Access Compliance Report Public Rights-of-Way (Curb Ramps)

Main Street: SKLAR_ST Cross Street: N/A Location: W

ADA ID: RPRK211103124958 Ramp Type: Type 4 - Parallel Initial Pass/Fail: Pass Overall Compliance: No Severity Score: 25

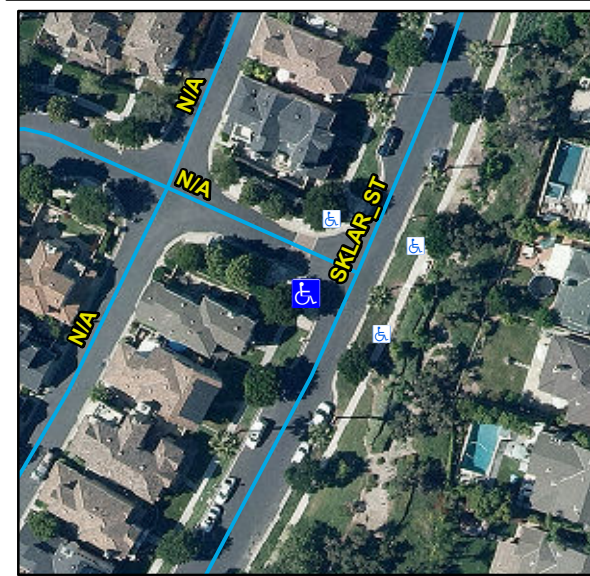
Compliance	Description	Data	Compliance	Description	Data
N/A	Ramp Length LT (in)	131	N/A	Ramp Length RT (in)	132
Yes	Ramp Width LT (in)	90	Yes	Ramp Width RT (in)	90
Yes	Ramp Run Slope LT (%)	5.2	Yes	Ramp Run Slope RT (%)	6.6
Yes	Ramp Cross Slope LT (%)	0	Yes	Ramp Cross Slope RT (%)	0.6
N/A	Landing Present	No	No	DWS Provided	No
N/A	Landing Length (in)	N/A	N/A	DWS Contrast	N/A
No	Landing Width (in)	N/A	N/A	DWS Length (in)	N/A
No	Landing Run Slope (%)	N/A	N/A	DWS Full Width	N/A
No	Landing Cross Slope (%)	N/A		DWS Offset Type	N/A
N/A	Landing Movement Obstructed?	No	N/A	DWS Offset Left (in)	N/A
	Landing Movement Type	Curb	N/A	DWS Offset Right (in)	N/A
N/A	Landing Shared	N/A			
N/A	Clear Space	Yes			
N/A	Clear Space To Crosswalk (in)	48			
N/A	Marked Crosswalk 1	No	N/A	Marked Crosswalk 2	No
	Crossing 1 Direction	SE		Crossing 2 Direction	NE
N/A	Marked Crosswalk 1 Width (in)	N/A		Marked Crosswalk 2 Width (in)	N/A
N/A	Ramp Inside Crosswalk 1	N/A	N/A	Ramp Inside Crosswalk 2	N/A

Crossing 1 Slope (%)	0.7		Crossing 2 Slope (%)	3.1
	Crossing 1 Cross Slope (%)	0.3		Crossing 2 Cross Slope (%)	1.5
Yes	Gutter Ponding	No	Yes	Curb Slope	7.6
Yes	Gutter Lip Height (in)	0		Road Run Slope (%)	0.6
No	Gutter Run Slope (%)	5.7		Road Cross Slope (%)	3.7
Yes	Gutter Cross Slope (%)	0.4	No	Perpendicular Joint Present	No
Yes	Overall Surface Condition	Acceptable			
	Cross Gutter Present?	No		Spandrel Present?	No
	Replace Cross Gutter?	N/A		Replace Spandrel?	N/A

Possible Solutions:
Remove & Replace Curb Ramp With Two New Directional Ramps or Equivalent. Remove & Replace Gutter.
